# Red Line Master Schedule

## Version 10.7 Analysis

July. 2017

| Doc ID | Project | Entity | Line | Package | Doc. Type | Chrono NO | Version |
|--------|---------|--------|------|---------|-----------|-----------|---------|
| Code:  | 8162    | ERA    | RED  | CMN     | TRP       | 120325    | C       |

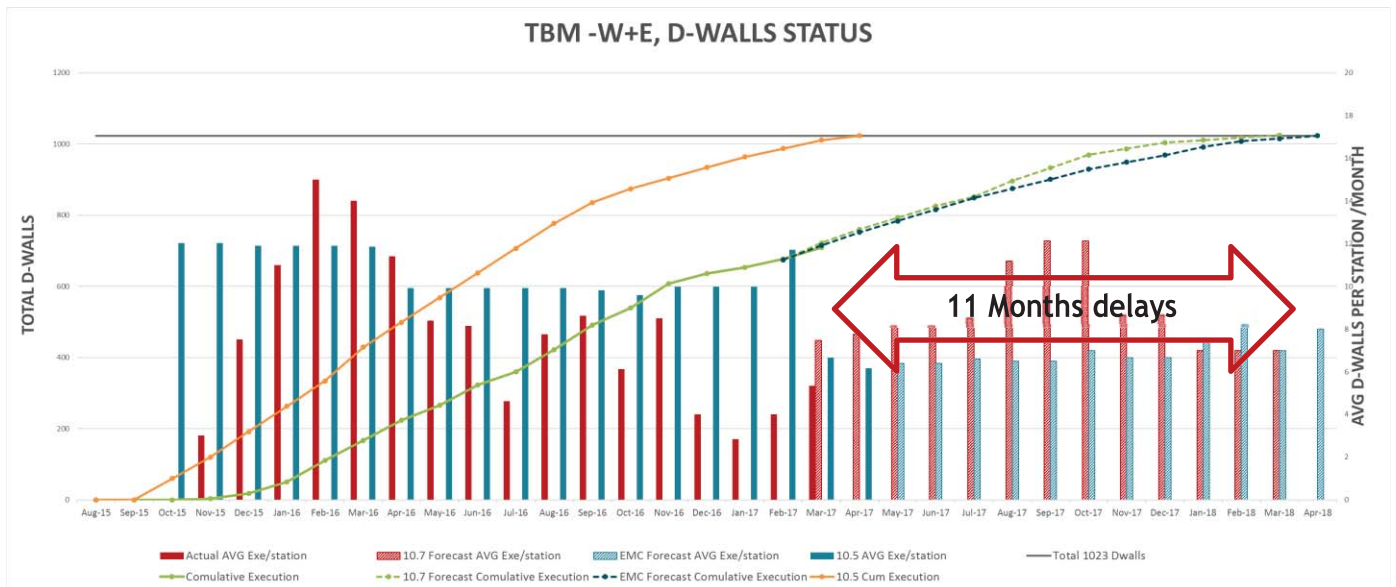
Almost 95% of tunneling are planned to be completed earlier than in 10.5, though EMC believe the basic assumption about the rate of progress are too optimistic. As result the impact that TBM 1st has on the stations is significant. The TBMs, due to TBM 1st create the constraints for the stations construction sequence which delay the station excavation & concreting works progress. Due to the earlier passage at the stations, the continuity of works will stop until the TBM will finish its drive at the last station and will be taken out of the tunnel. EMC believe that all TBMs are now part of the critical path rather than as shown by NTA in the "**top 3 critical paths.pdf**" that only TBM 3# in the critical path.

The narrative report does not describe the assumptions of TBM construction (e.g. where TBMs have to stop, rate of progress within and outside of a station, how the average advancement rates used or how they were derived). EMC can comment that compare to other projects learning curve experience the rates achieved by the two TBMs so far are considered reasonable.
